Highway Improvements Team working in Partnership with Kennington Community Council Highway Improvement Plan

Submission Date: February 2024

Live Priorities Record

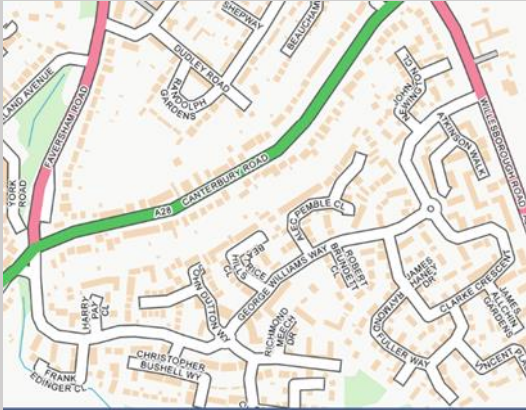
<p>Rothbrook Drive</p>			<p>There is an awkward corner, circled, with a well-used pedestrian crossing point (including by pupils at Goat Lees school) and corner parking. Residents have raised issues regarding traffic speeding westbound into the corner, conflicting traffic south of the corner, and especially the safety of pedestrians crossing at this point. On boundary with Boughton Aluph & Eastwell PC</p>	<p>Implement 'pedestrians in road' warning sign and 'SLOW' road marking on westbound approach - funding to be identified</p>	<p>28/11/2022-</p> <p>KCC to find out cost of a pedestrian in the roadway warning sign and a slow marking.</p> <p>KCC to ascertain if able to fund for PC</p> <p>20/12/2022-</p> <p>Traffic Signs Manual states signage not appropriate as not a formal crossing. Manual sent to PC. SLOW marking would accompany signage so not feasible.</p> <p>KCC have arranged for vegetation to be assessed for cutting back to create better line of sight for the informal crossing.</p>
